Groundwater & Wastewater Services
Septic Project File & Data Review Worksheet

GWS File #: 7626B WASPS App #: 3255

APPLICATION FOR A RESIDENTIAL SITE IMPROVEMENT PERMIT/ CONSTRUCTION AUTHORIZATION FOR AN ON-SITE WASTEWATER SYSTEM, NEW WELL INSTALLATION, OR REPAIR OF EXISTING WELL

Attached is a proposed design for a PPBPS Septic System with low pressure distribution for a 6 bedroom single family residence on Lot # 55 in ABERSHAM Subdivision, Mecklenburg County, North Carolina.

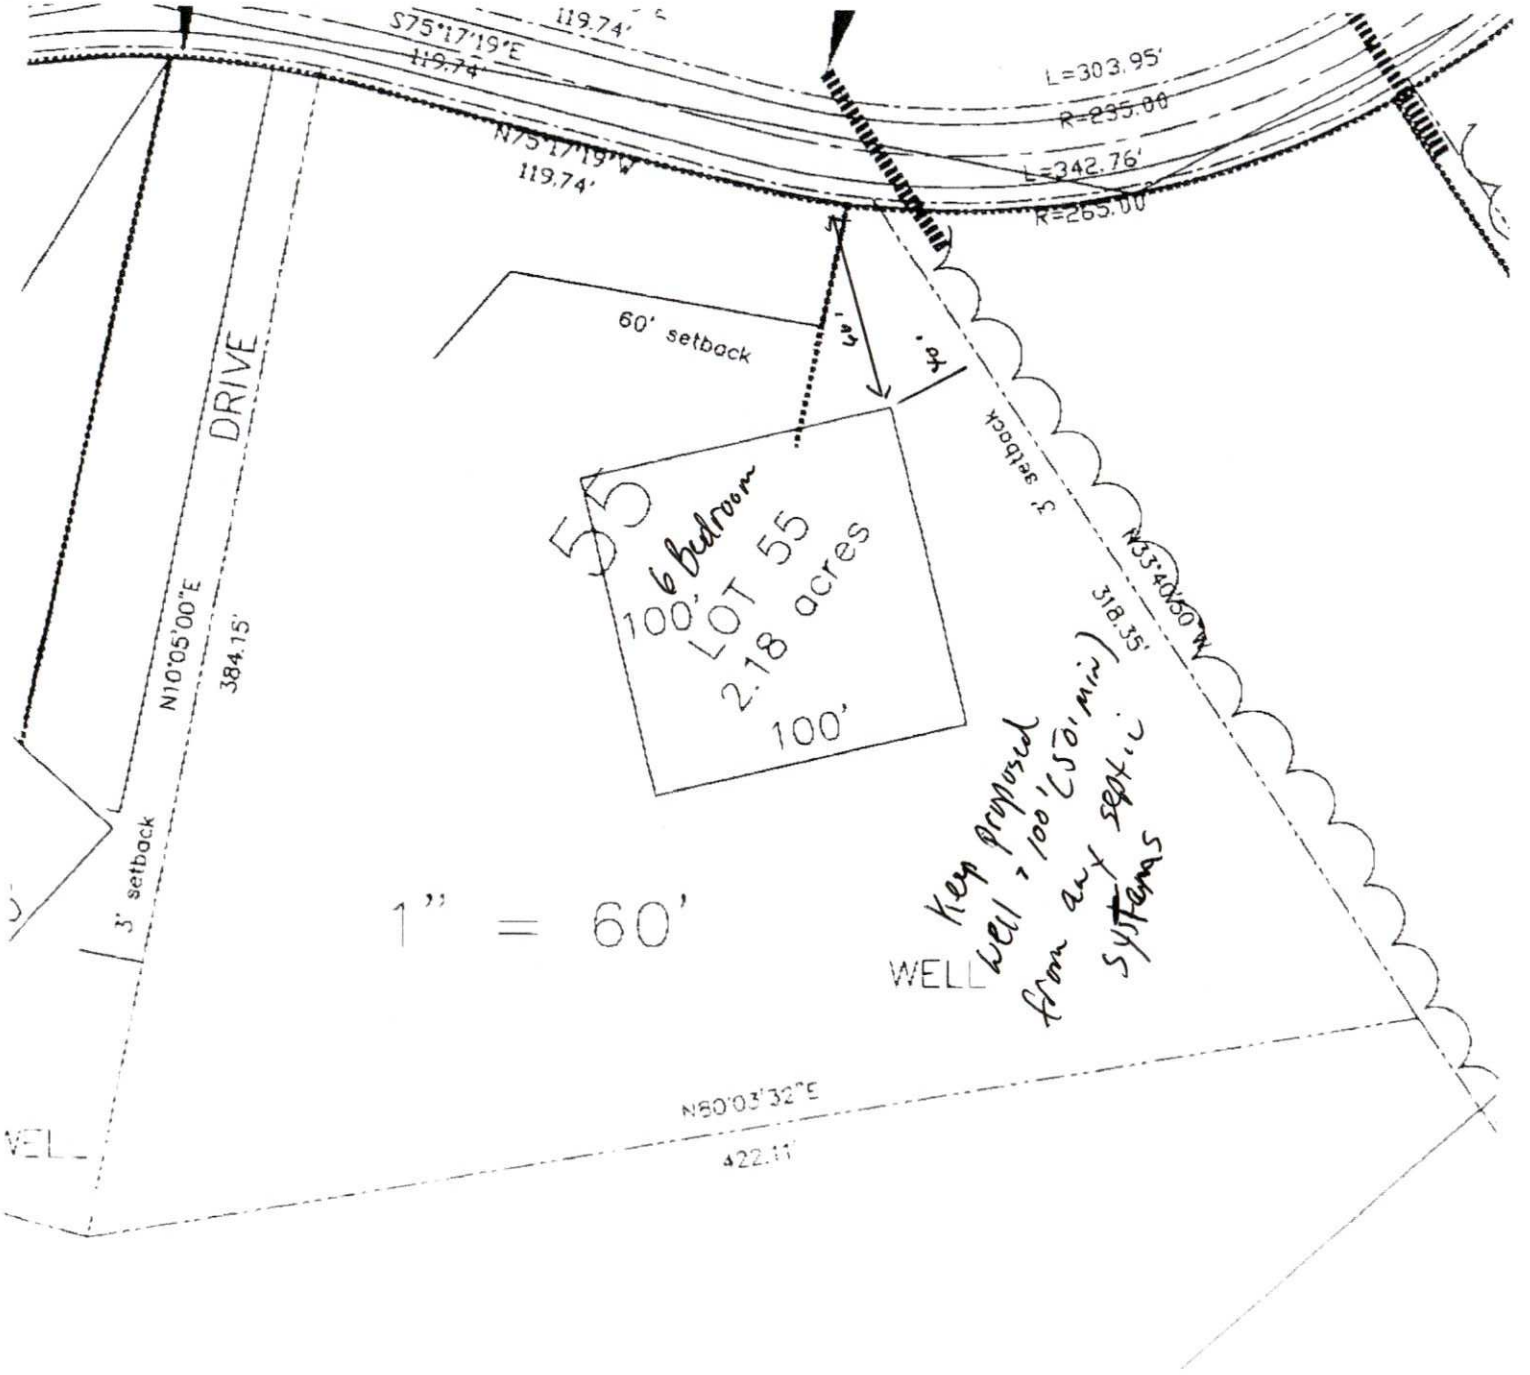
Keep the septic system > 100' (50' min) from any wells

S75°17'19"E
119.74'
119.74'
N75°17'19"W
119.74'
L=303.95'
R=235.00'
L=342.76'
R=265.00'
60' setback
DRIVE
N10°05'00"E
384.15'
3' setback
55
6 bedroom
100'
LOT 55
2.18 acres
100'
3' setback
N33°40'50"W
318.35'
1" = 60'
Keep proposed well, 100' (50' min) from any sept. systems
WELL
N80°03'32"E
422.11'
